M4 Junctions 3 to 12 Smart Motorway

Non-Material Change Junction 5 No Through junction Running Technical Note

Document Number: HA514451-CHHJ-GEN-SZ-ZZZZZZZZ_Z-TN-KK-0040

April 2022

Figure 1 Junction 5 Eastbound AM peak flows

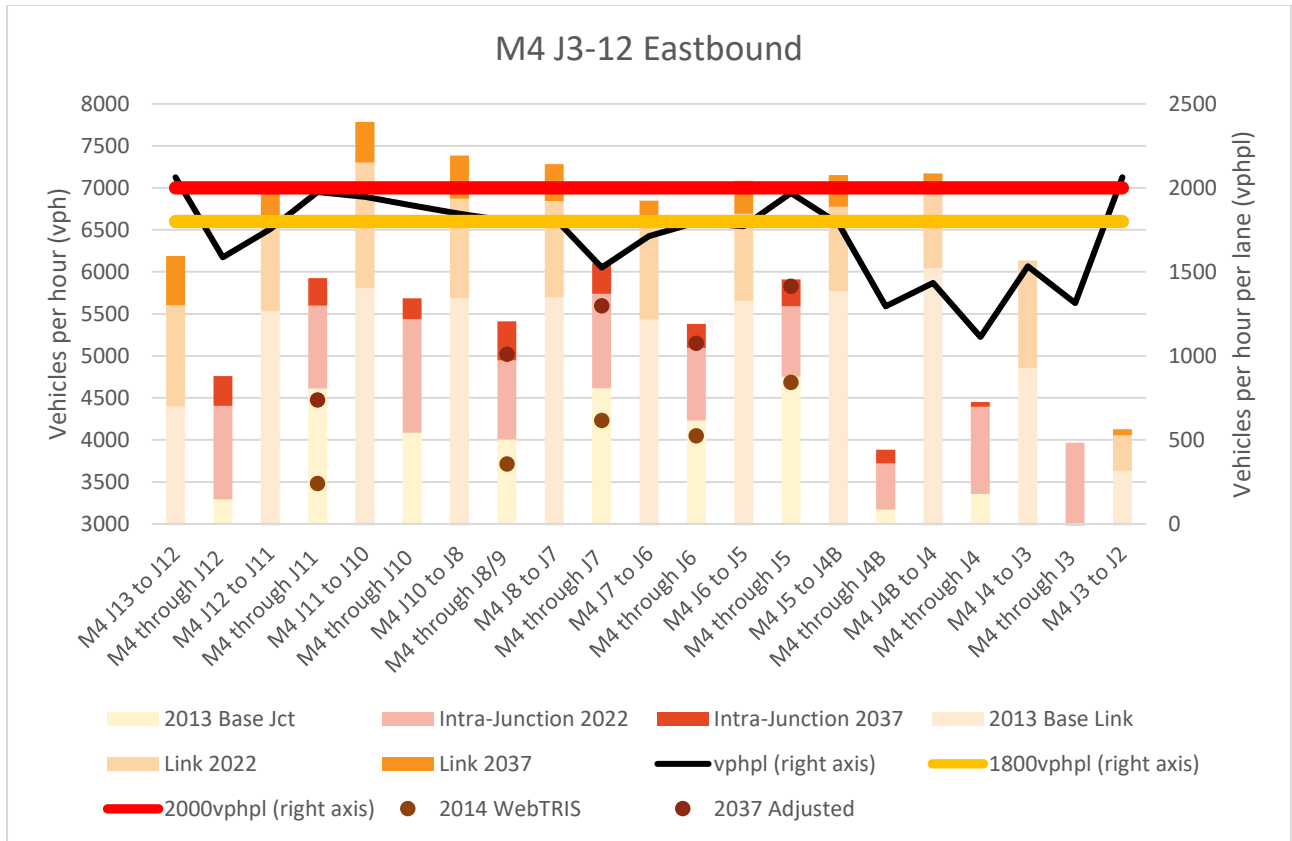
The traffic model data indicates intra junction flow without TJR (three lanes) will be 5590 vehicles per hour (vph) (i.e. less than 2000 vph per lane) compared to 5730vph with TJR in the opening year (2022) and 5910 vph (i.e. less than 2000 vph per lane) compared to 6125vph with TJR in the design year (2037). Flows on the upstream mainline link are also forecast to be approximately 1800vph per lane in 2037, indicating similar levels of risk of congestion as intra junction with No TJR or TJR.

Therefore, the adoption of No TJR at junction 5 is expected to have no significant impact on the overall scheme benefits in terms of traffic flow.

Figure 2 Junction 5 Westbound PM peak flows

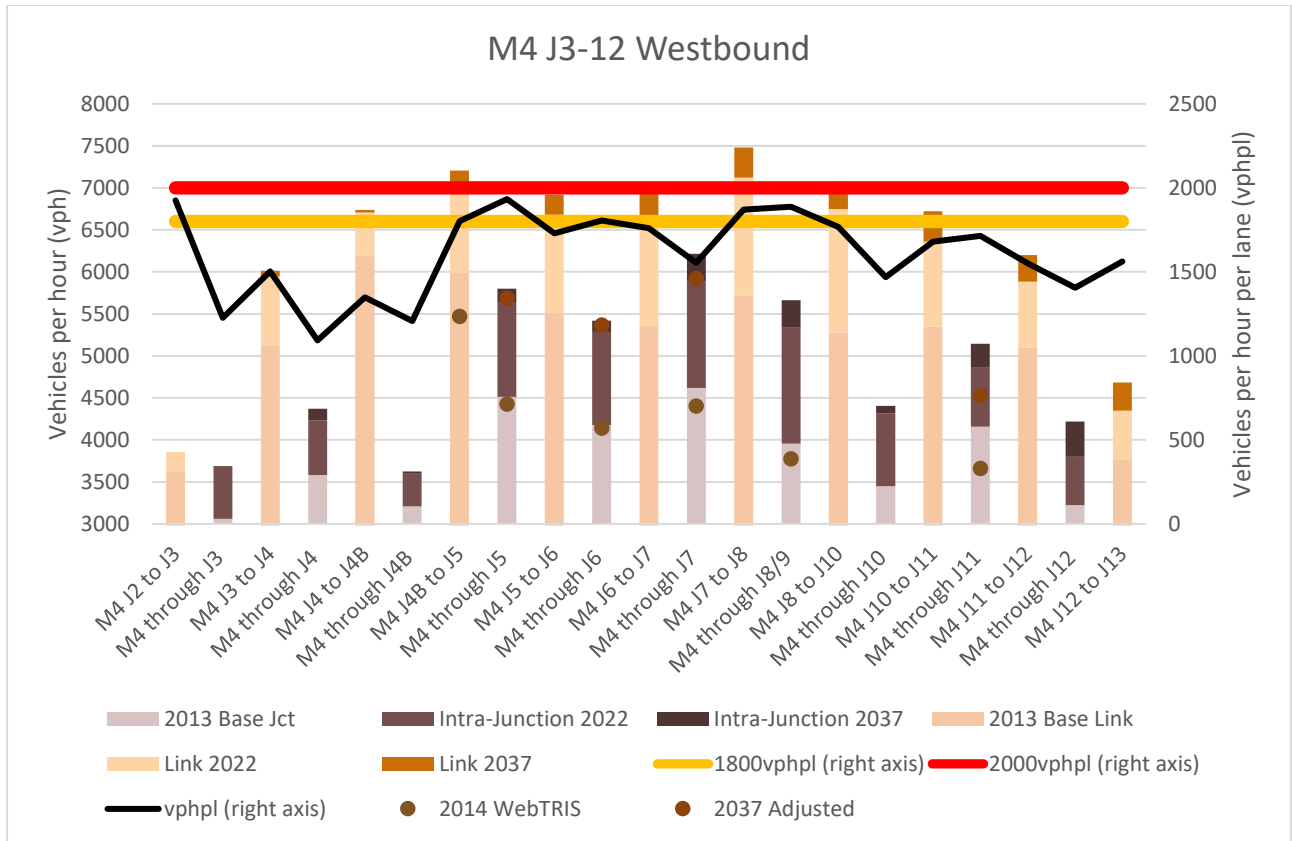
The traffic model data indicates intra junction flow with No TJR (three lanes) will be 5630vph (i.e. less than 2000vph per lane) compared to 5765vph with TJR in the opening year, and 5800vph with No TJR (i.e. less than 2000 vph per lane) compared to 5970vph with TJR in the design year. Flow on the upstream mainline link is forecast to be 7205vph with No TJR, slightly less than 7320vph with TJR in 2037, indicating similar levels of risk of congestion as intra junction with No TJR.

Figure 4 Schematic showing layout with junction 5 without TJR

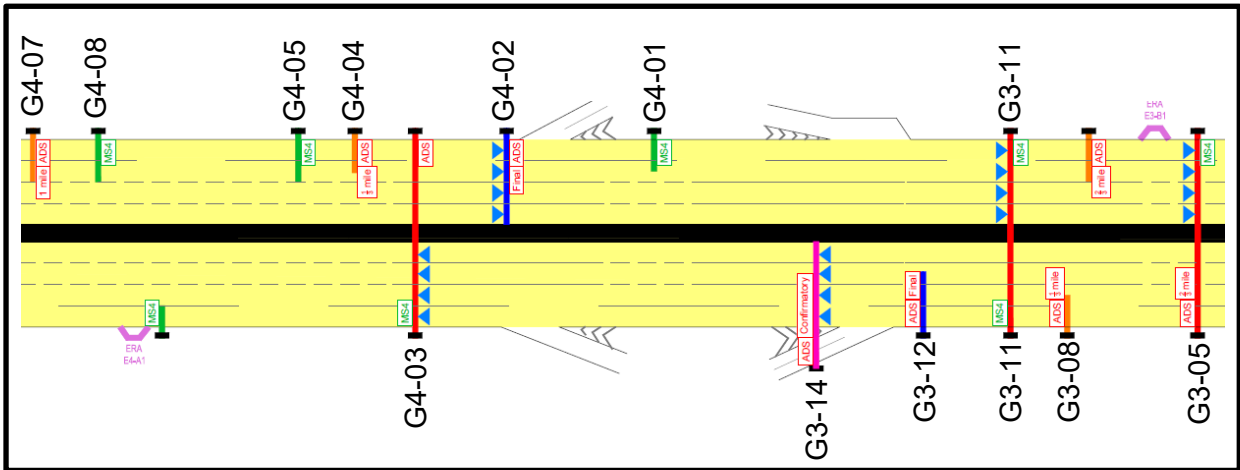
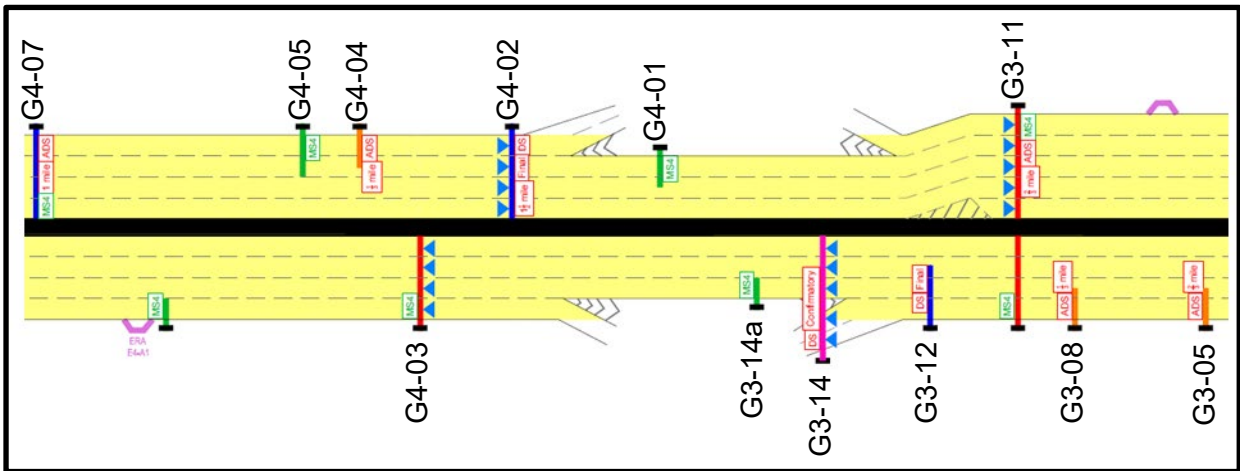
Figure 3 shows a schematic of the previously proposed TJR layout of junction 5, with four lanes through the junction on both carriageways.

Figure 4 shows the current proposed layout of junction 5 (with No TJR). The No TJR proposed layout at Langley Interchange is a lane-gain/lane-drop arrangement maintaining the three existing lanes and hard shoulder (discontinued across and between the underbridges) in each direction through the Interchange. The alignment and associated lining have been designed to fit within the existing footprint the overbridge at junction 5.

Figure 6 Noise level changes (DS22 No TJR) minus (DS22 With TJR)

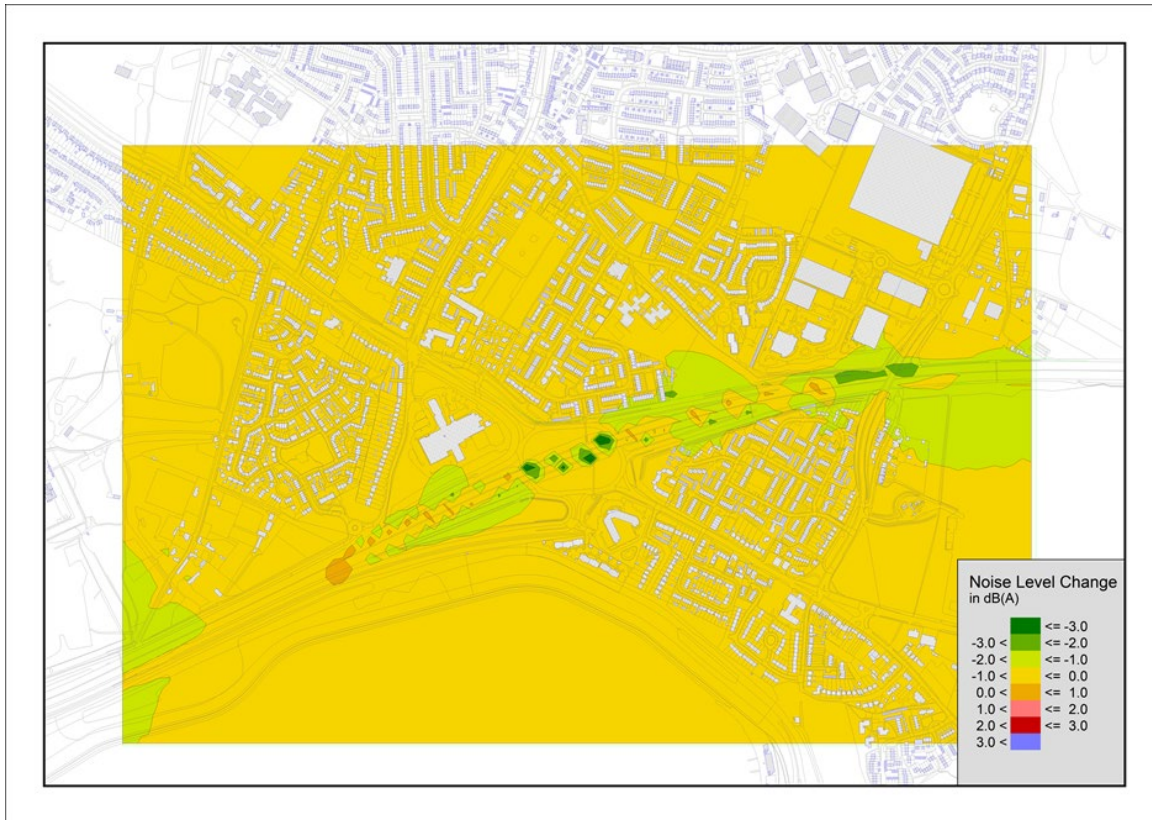
It can be seen that there are generally negligible noise level decreases across the surrounding area as a result of adopting No TJR when compared with TJR.
